Project Name: Jax Car Wash

Description: Preliminary Site Plan approval and PB Approval

**RE: Jax Kar Wash- Preliminary Site Plan Review – 2<sup>nd</sup> Review**

**Preliminary Site Plan / Planned Business Review  
for  
White Lake Charter Township, Michigan**

NORTH ELEVATION

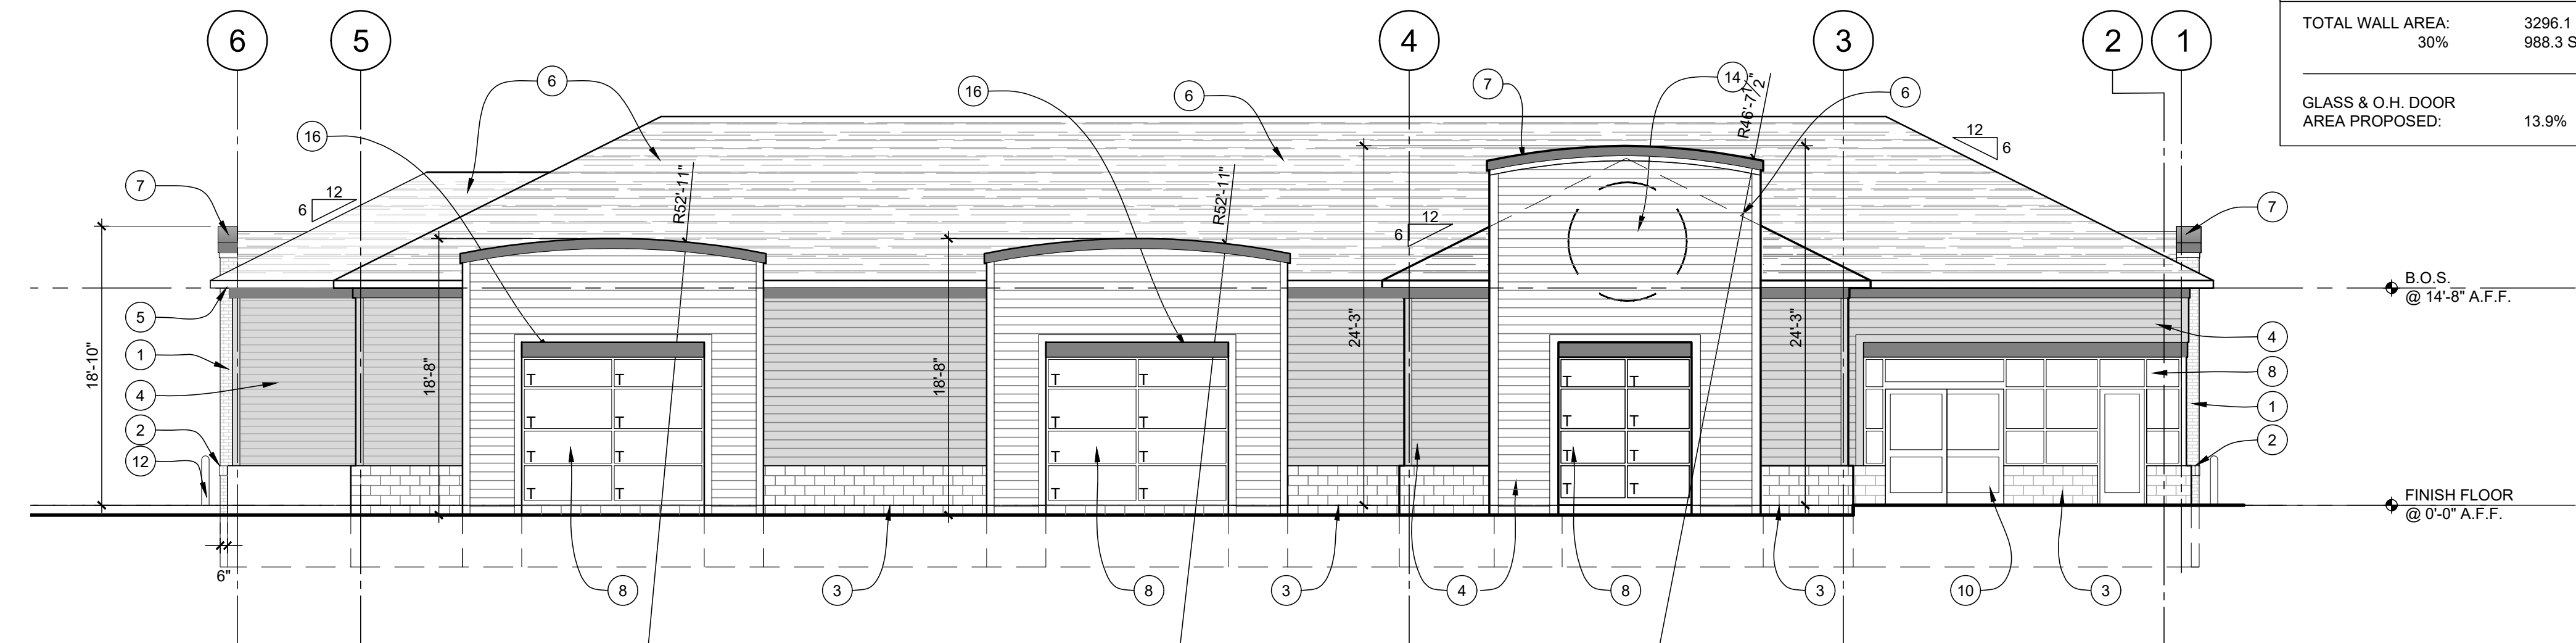
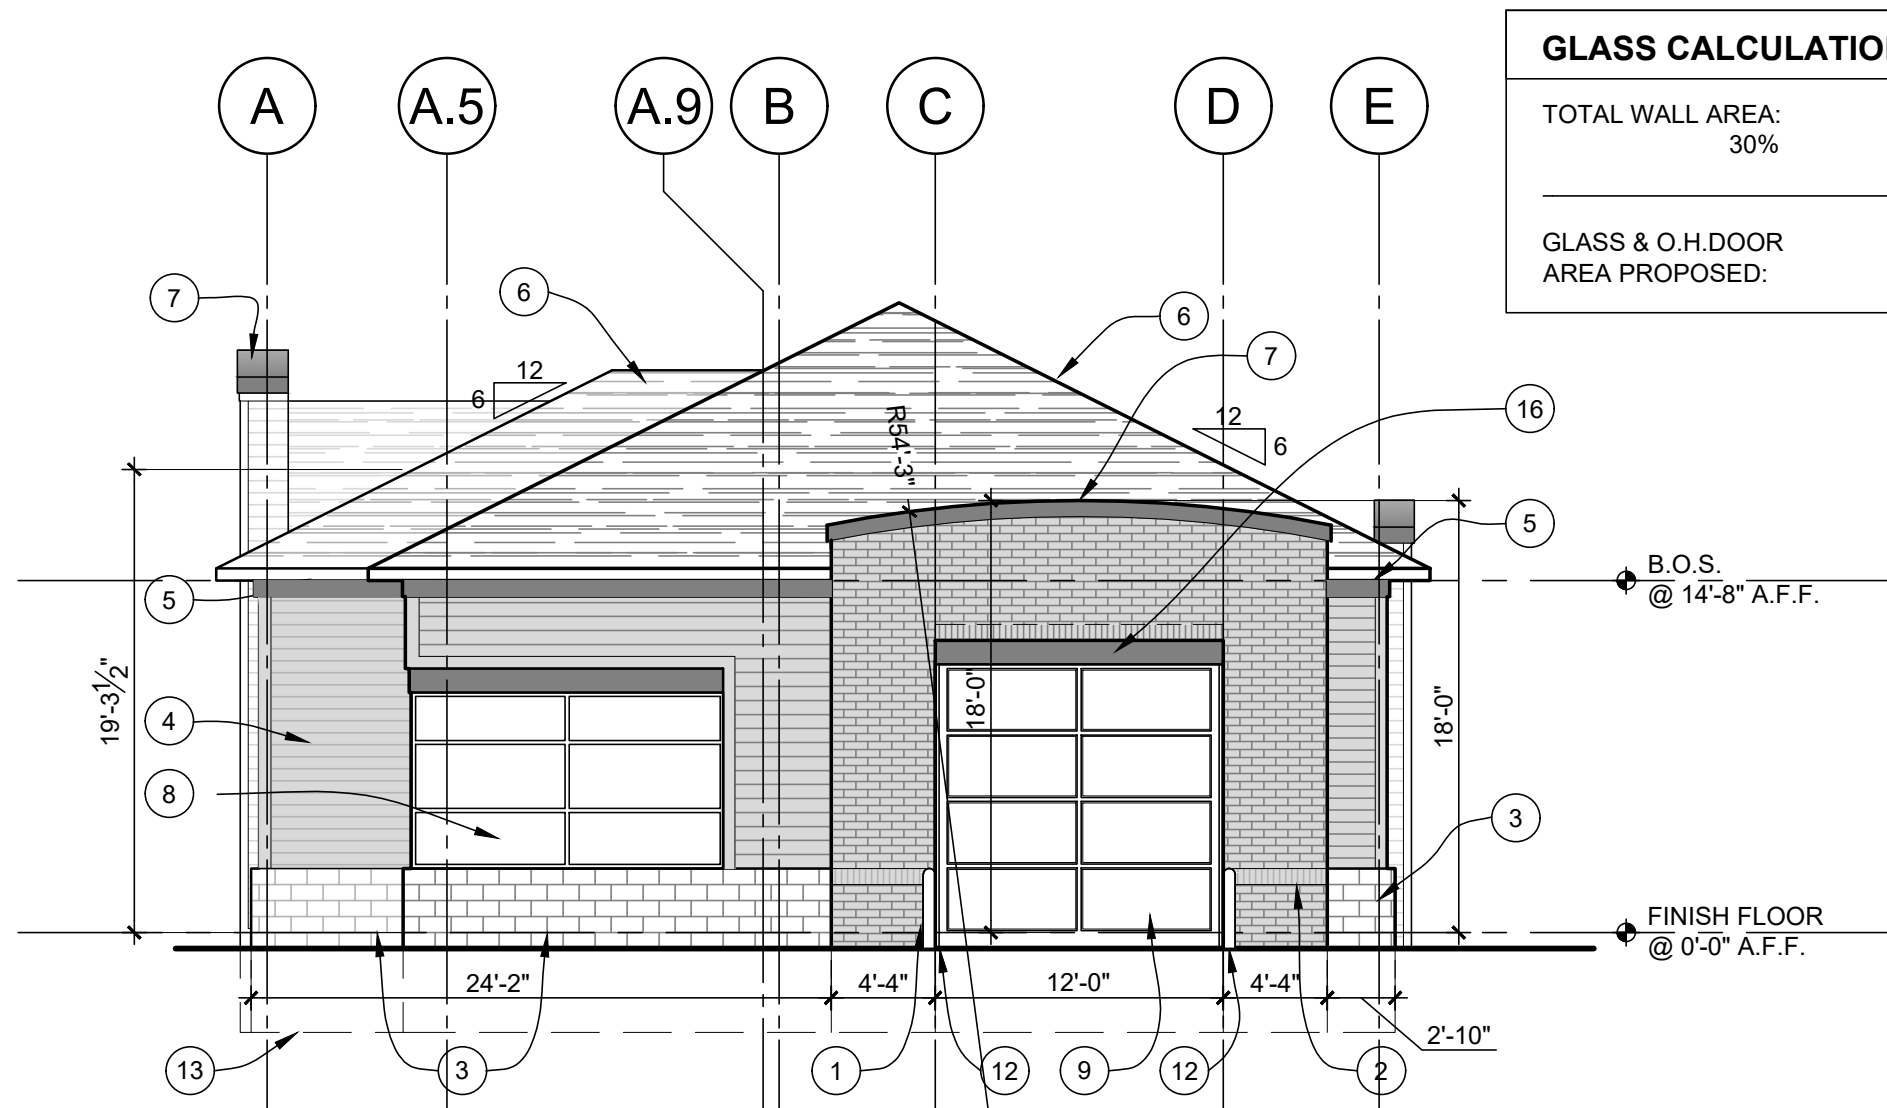
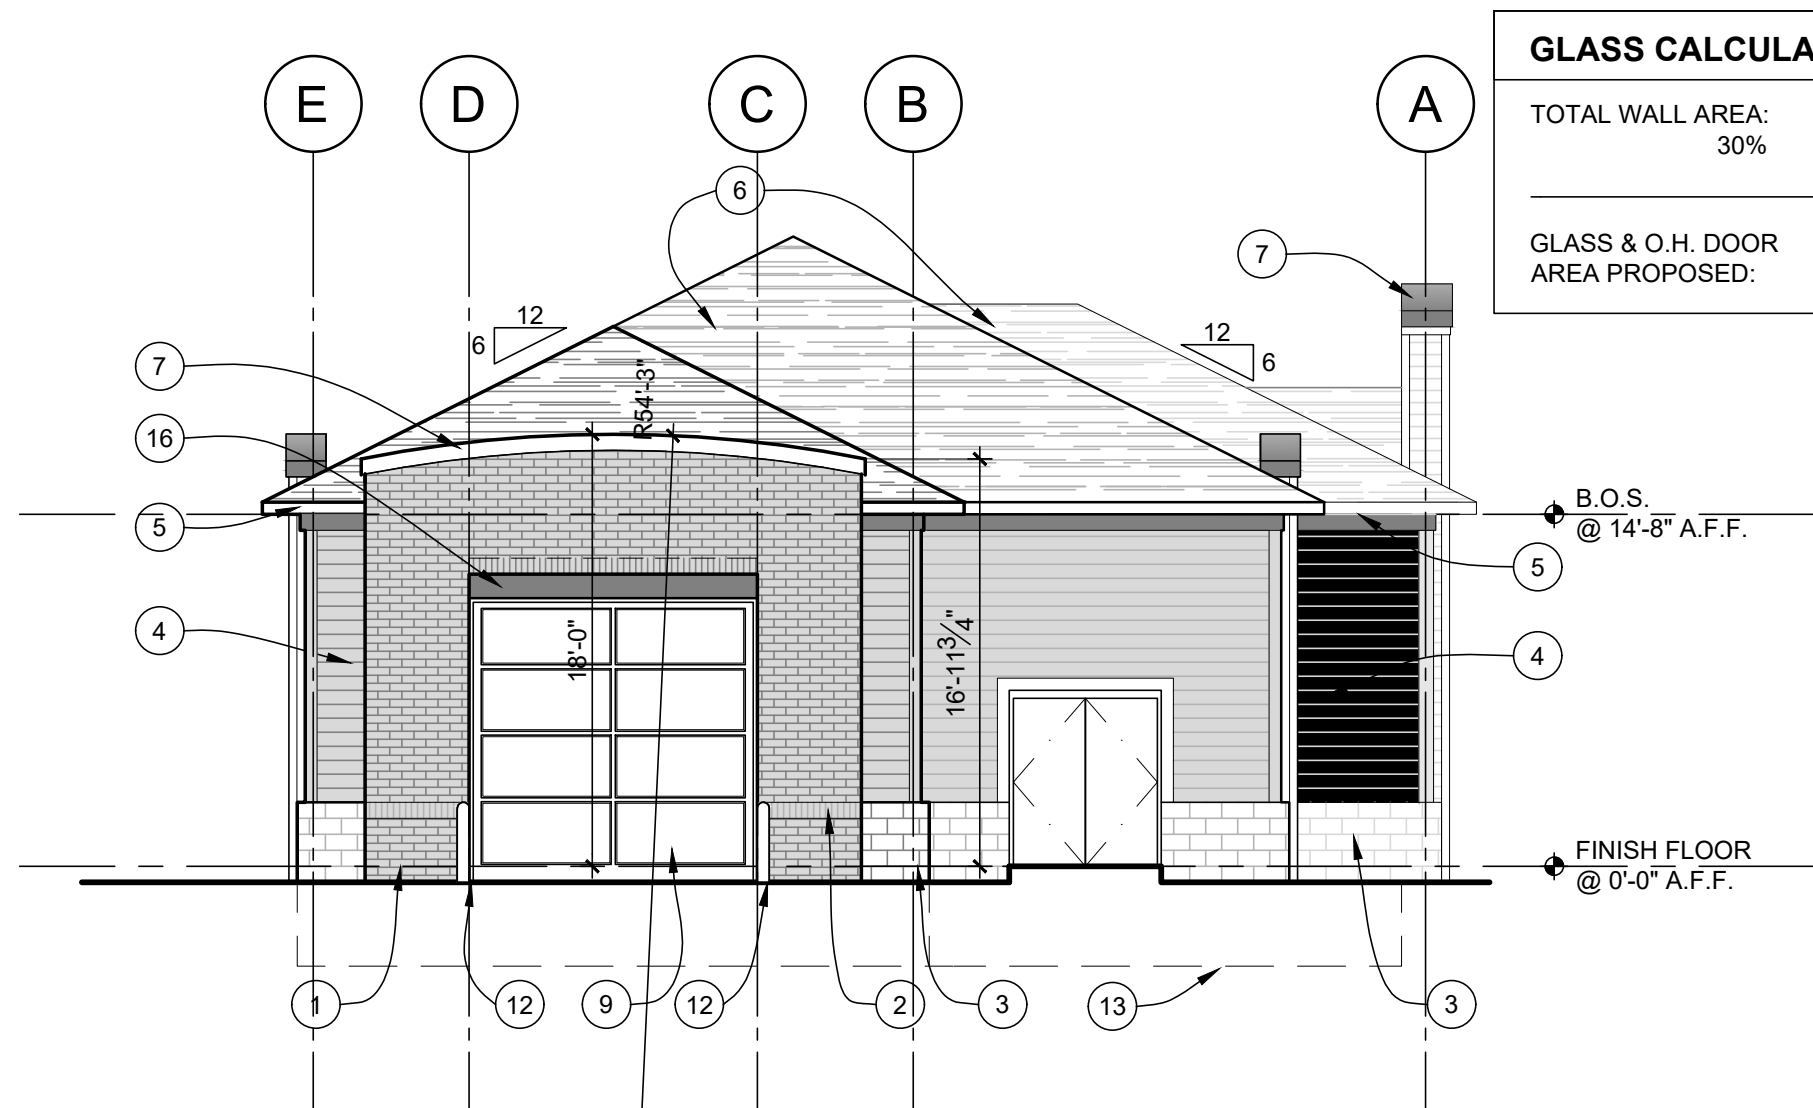
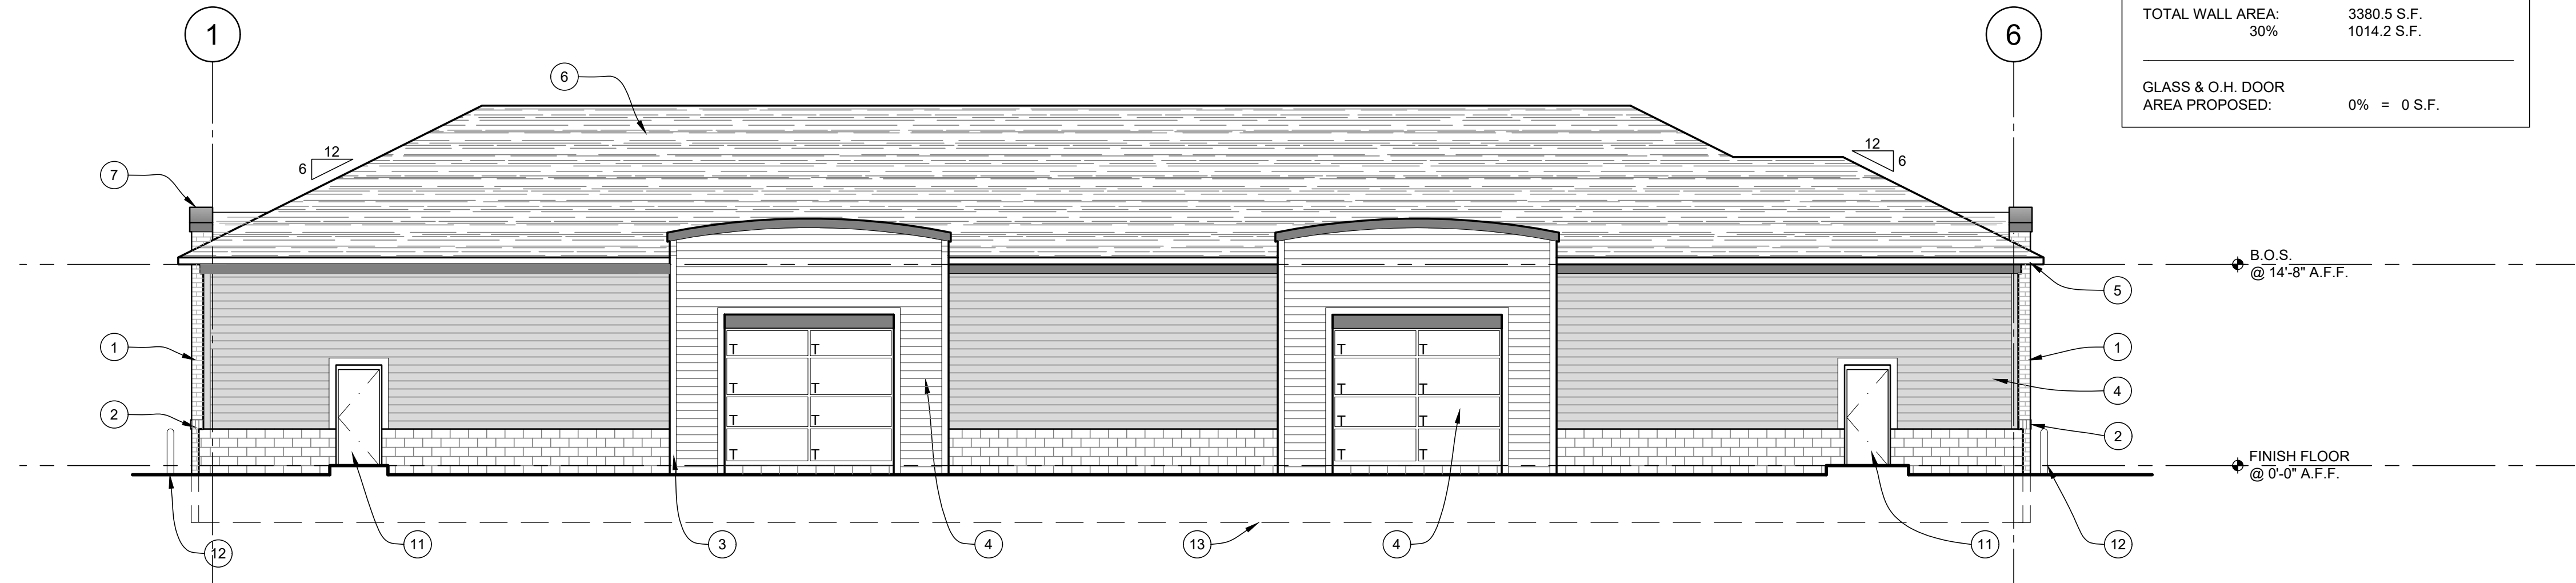
Garage doors are not permitted to face streets. The Planning Commission will need to consider a waiver for the north and south façade garage doors. Windows are provided on all three front facades. Front facades must offer at least 30% window coverage. The south elevation offers 14.4% window coverage, the North elevation offers 25.2% window coverage, and the East elevation offers 13.9% window coverage.

- 1) *Planning Commission to consider whether proposed exterior construction materials are appropriate.*
- 2) *Planning Commission to consider waiving the prohibition of garage doors facing Highland Road and Audbon Drive.*
